Memorandum

RE: 99 Sumner Street/DeNormandie Wharf Project, East Boston (the "Proposed")

DATE: June 29, 2017

2. <u>Project Design</u>. The revised design for the Proposed Project is shown on the perspectives, renderings, site plan and elevations included as <u>Exhibit A</u> to this Supplemental Submission. A summary of these changes is as follows:

99 SUMNER STREET | DENORMANDIE WHARF | EAST BOSTON, MA GROUND FLOOR PLAN

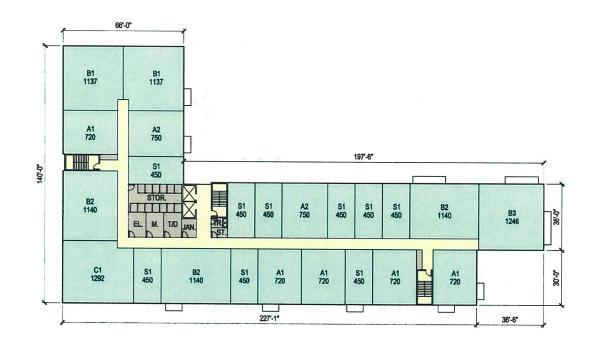
- (a) The location of the garage entrance/exit has been moved from Sumner Street to London Street Extension to facilitate pedestrian access to LoPresti Park. This is the same general driveway location as was approved for the original project design by the BRA, the BCDC and the Parks Commission in 2004-2005.

- (b) The design of the open space areas has been refined as follows:
 - (i) the Harborwalk's primary path of passage and pedestrian sight lines between LoPresti Park and Carlton Wharf have been widened and made more direct;

- (ii) the overall grade change between the elevated courtyard open space and the Harborwalk has been reduced from the originally proposed 7' to 4-1/2' at the southeastern corner, and an amphitheater has been designed to facilitate this grade change, while at the same time creating a public amenity;
